Addendum # 2

Bid Opportunity: 25-7630-RFT - Laurentian Public School HVAC and Building Controls Upgrade

SHEET NO. :A102

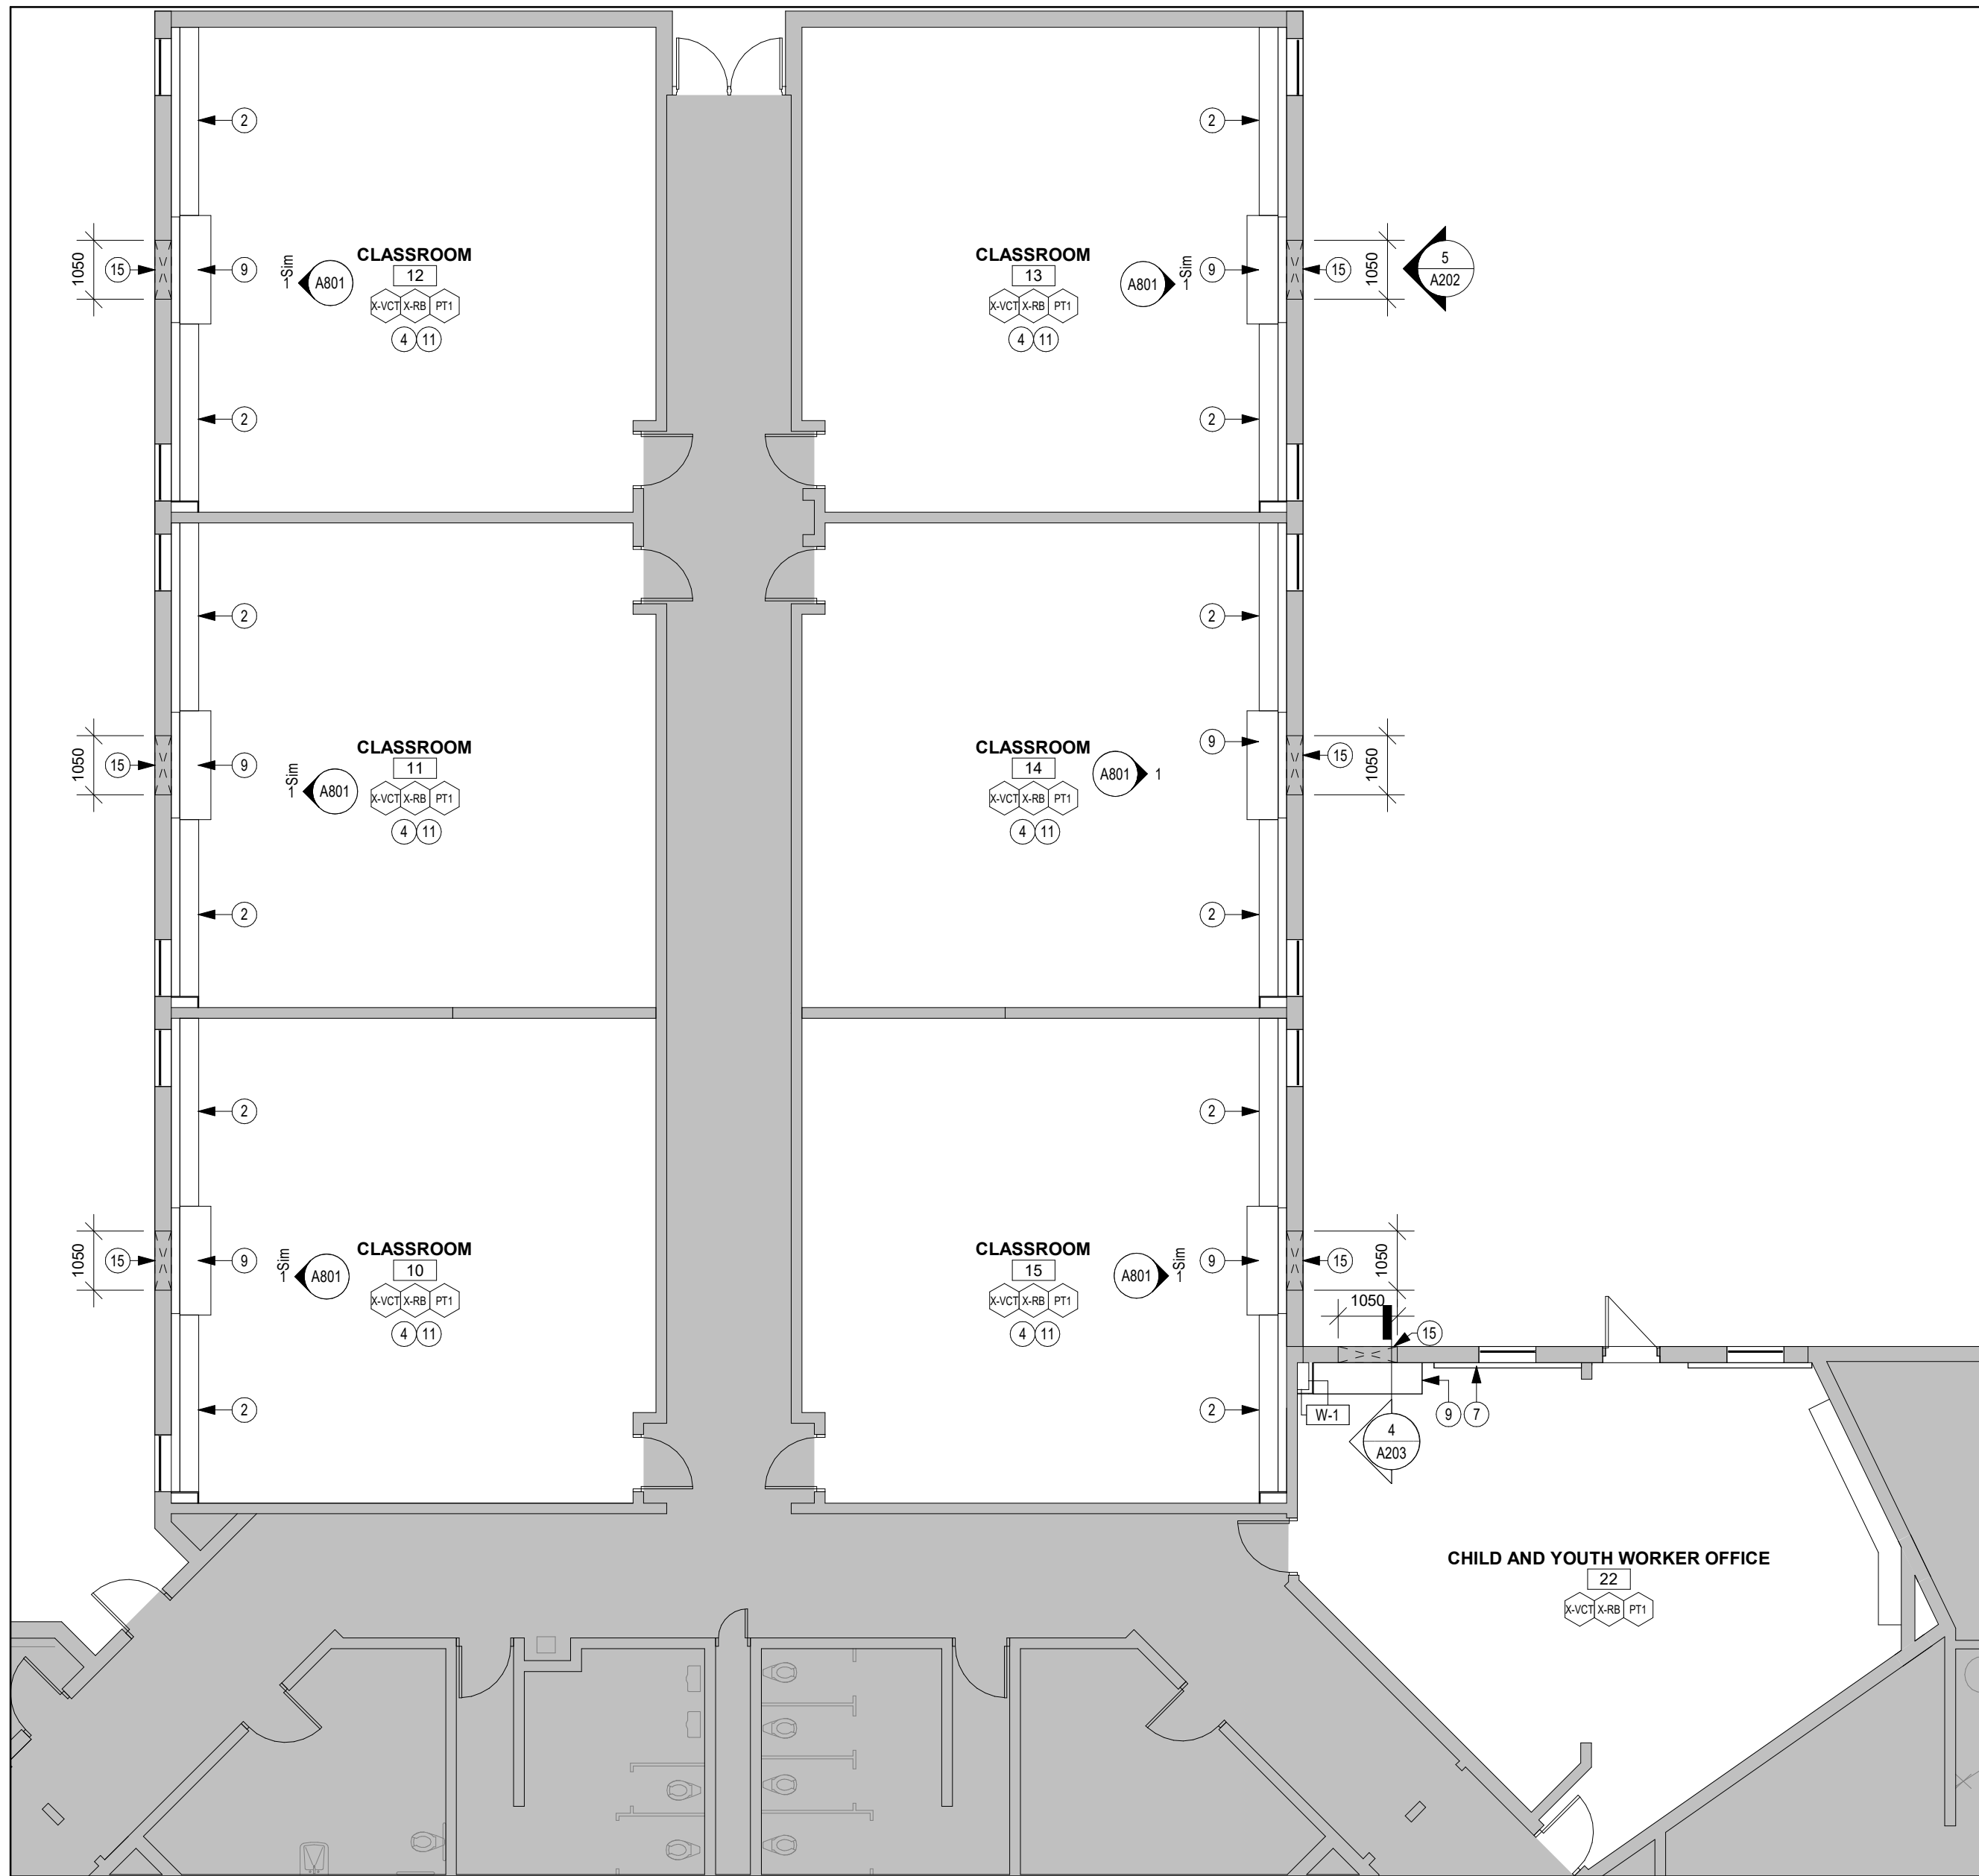
Temporarily remove benches, refer to changes to architectural drawings A102 and A202 in this addendum.

CHANGES TO ARCHITECTURAL DRAWINGS**Drawing A102 Partial Ground Floor Plan Demolition Plan**

1. In Life Skills Room (16), Science Room (17) and Music Room (21) revised demolition note 03 to demolition note 04. See attached drawing A102.

2. In Demolition Notes added demolition note 20 'Temporarily remove benches and store on site to allow for re-finish of wood floor. Refer to electrical demolition drawings E301 for electrical disconnect of receptacles.'
3. In Science Room (17) added benches and demolition note 20 to benches.

- TEMPORARILY REMOVE BENCHES AND STORE ON SITE TO ALLOW FOR RE-FINISH OF WOOD FLOOR. REFER TO ELECTRICAL DEMOLITION DRAWING E301 FOR ELECTRICAL DISCONNECT OF RECEPTACLES.
